EGNATER MOD100 NOISE FIX:

THIS IS A REAR VIEW OF THE MIDI BOARD. PLEASE SEE BELOW FOR DETAILS.

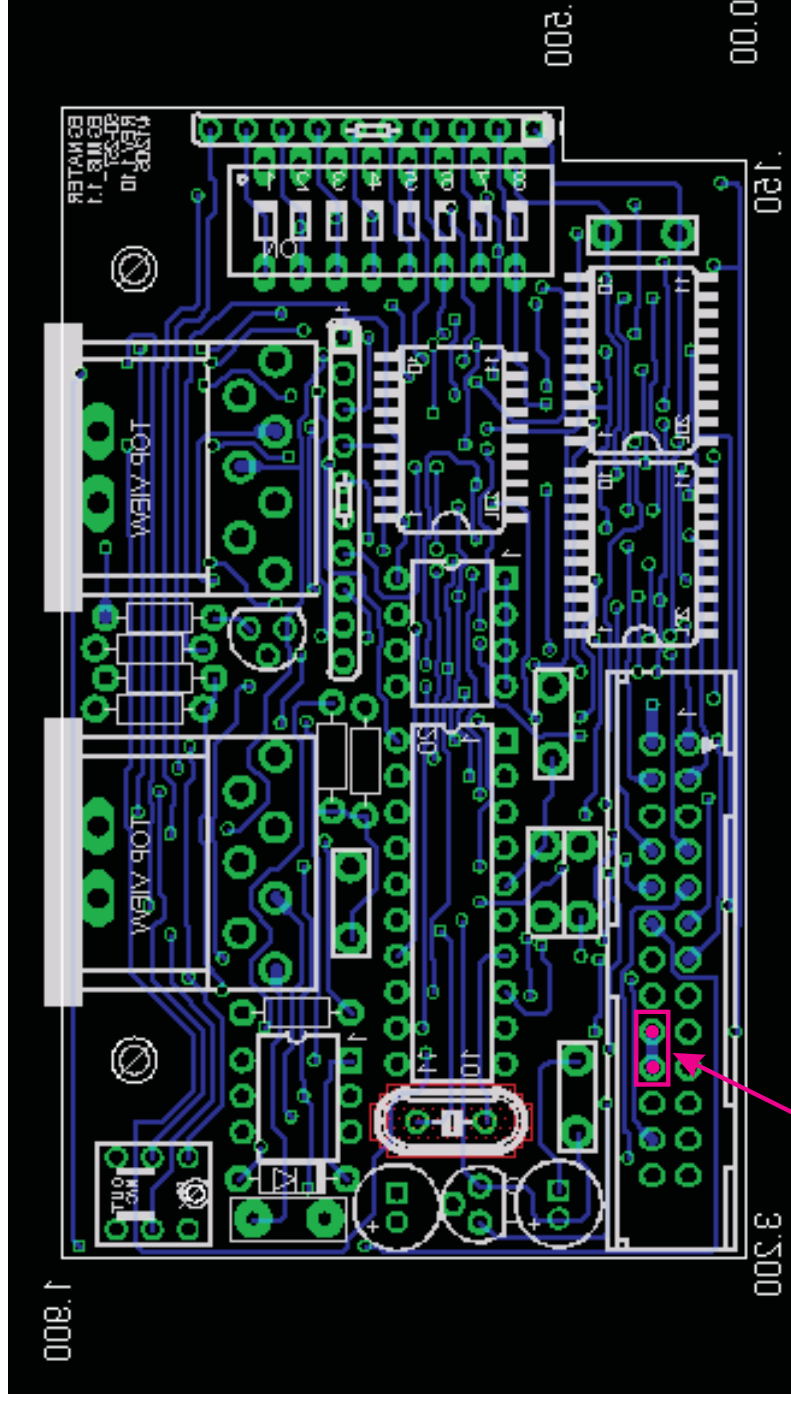
- 1) REMOVE THE REAR METAL GRILL PANEL AND REMOVE THE CHASSIS FROM CABINET (FOUR SCREWS ON BOTTOM)
- 2) TURN THE CHASSIS OVER WITH REAR PANEL FACING YOU.
- 3) REMOVE 2 SCREWS FROM REAR PANEL SECURING THE MIDI BOARD, LIFT IT OUT AND TURN OVER TO EXPOSE THE SOLDER SIDE.
- 4) MATCH THE ABOVE PICTURE TO THE MIDI BOARD IN YOUR AMP.
- 5) LOCATE THE 2 PADS INDICATED IN PURPLE.
- 6) PREPARE A 5" PIECE OF STRANDED HOOKUP WIRE BY STRIPPING ONE END VERY LITTLE ($> 1/16"$) AND STRIP THE OTHER END $\sim 1/8"$.
- 7) TIN THE $1/16"$ STRIPPED END AND SOLDER TO EITHER OF THE INDICATED PURPLE PADS ON THE MIDI BOARD.
- 8) SOLDER THE OTHER END DIRECTLY TO THE CHASSIS MOUNTED SOLDER LUG NEXT TO THE AC INLET.
- 9) REASSEMBLE. THAT'S IT. YOU SHOULD NOTICE A SUBSTANTIAL REDUCTION IN HUM.
